Town of Milford Meeting Notice

Board or Commission: Conservation Commission

Date and Time of Meeting: Wednesday April 21, 2021 at 7.00 P. M

AS-BUILT
 PLAN OF LAND
 IN
 MILFORD, MA
 SCALE: 40 FEET TO AN INCH
 DATE: MARCH 15, 2021

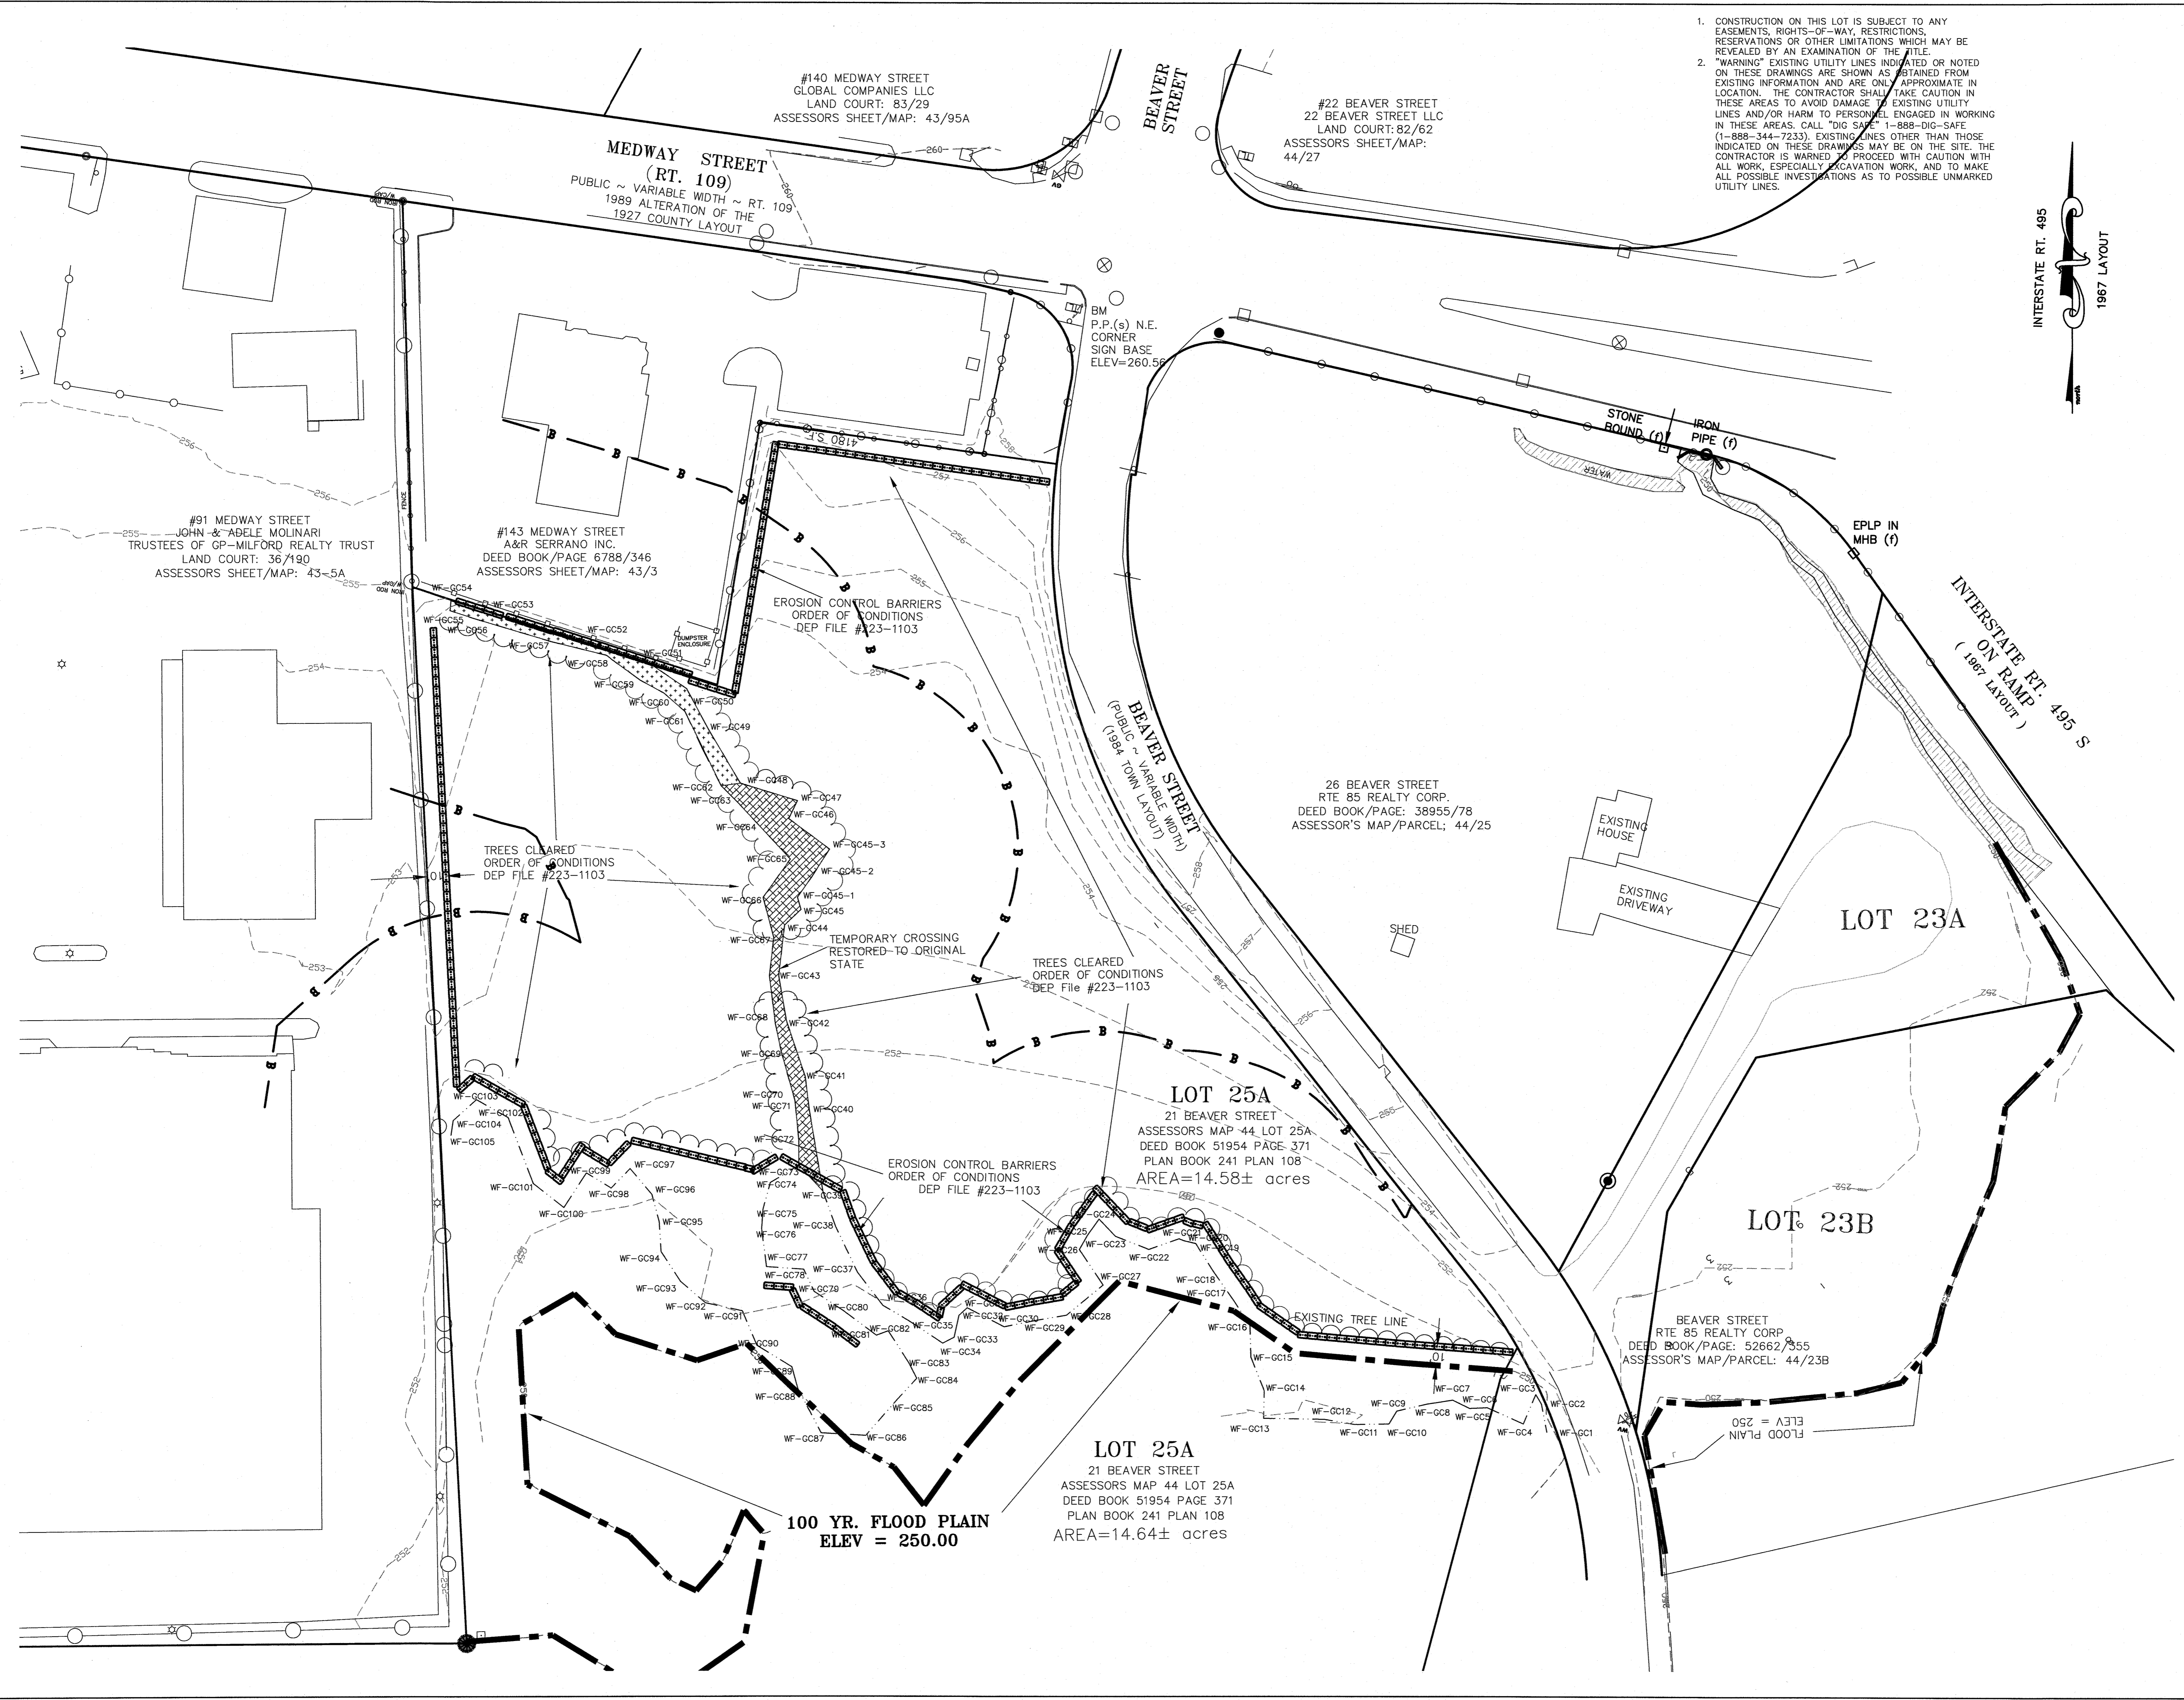
I have reviewed the request for a Certificate of Compliance to the Order of Conditions, DEP File # 223-1103. This particular request is associated with the first Order of Conditions (for the Parcel) that was issued in October 2016. This was for the clearing of trees and site preparation of a commercial lot.

The work has been completed and the Order of Conditions has expired.

I recommend the issuance of a Certificate of Compliance for DEP File # 223-1103.

AS-BUILT
PLAN OF LAND
IN
MILFORD, MA
SCALE: 40 FEET TO AN INCH
DATE: MARCH 15, 2021

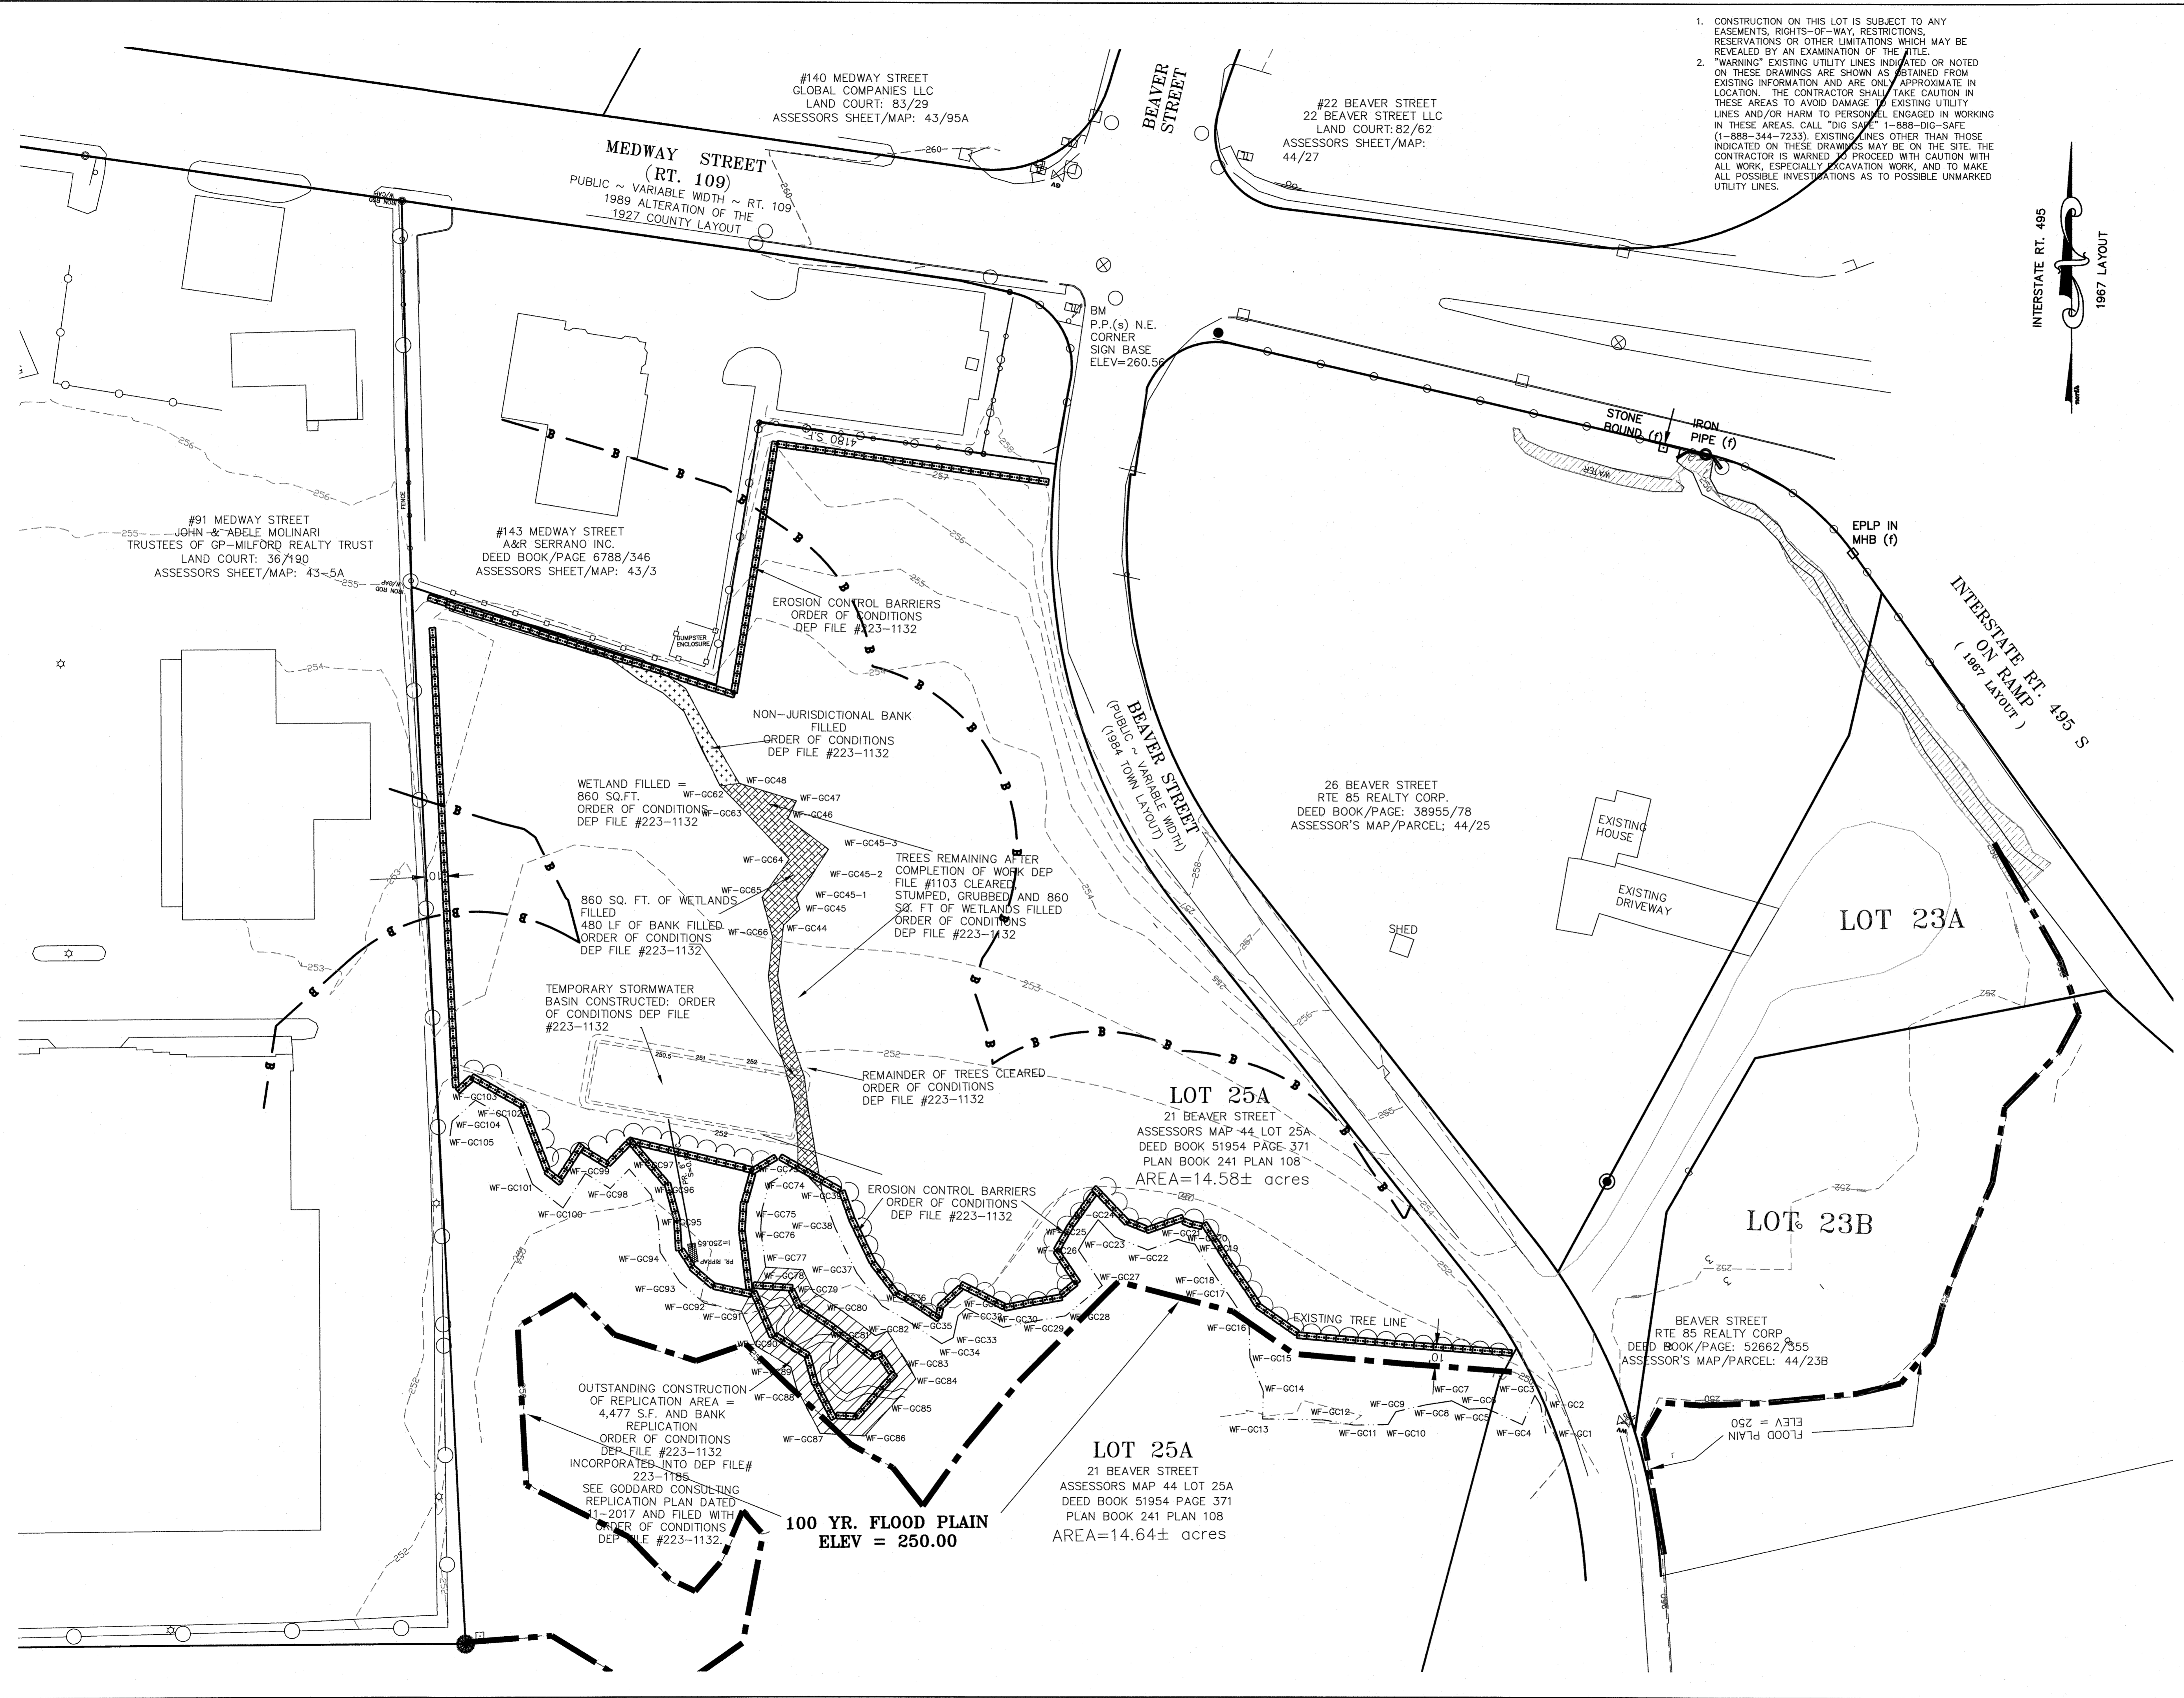
I have reviewed the request for a Certificate of Compliance to the Order of Conditions (OOC), DEP File # 223-1132. This particular request (2nd one) is associated with the 2nd Order of Conditions (for the Parcel) which was issued in November 2017. This was for the filling of wetlands and bank associated with the site preparation of a commercial lot and for the replication of the resource areas.

Portions of the work have been completed and other portions are still ongoing (as part of the 2nd Order of Conditions). The 2nd Order of Conditions has expired and therefore all outstanding work under the 2nd Order of Conditions should be incorporated into the 3rd filing, which is currently in front of the Commission under DEP File # 223-1185. Massachusetts DEP has also requested that all the work (associated with the parcel) be consolidated into one DEP File number / OOC.

"I HEREBY CERTIFY TO THE MILFORD CONSERVATION COMMISSION THAT THE WORK SHOWN HEREON IS IN SUBSTANTIAL COMPLIANCE WITH THE ORDER OF CONDITIONS DEP FILE #223-1132 EXCEPT FOR THE WETLAND AND BANK REPLICATION. SEE NOTE #10

I recommend the issuance of a Certificate of Compliance for DEP File # 223-1132 and that this Certificate of Compliance be held until the new / current Order of Conditions (for DEP File # 223-1185) is issued by the Commission and recorded by the Applicant.
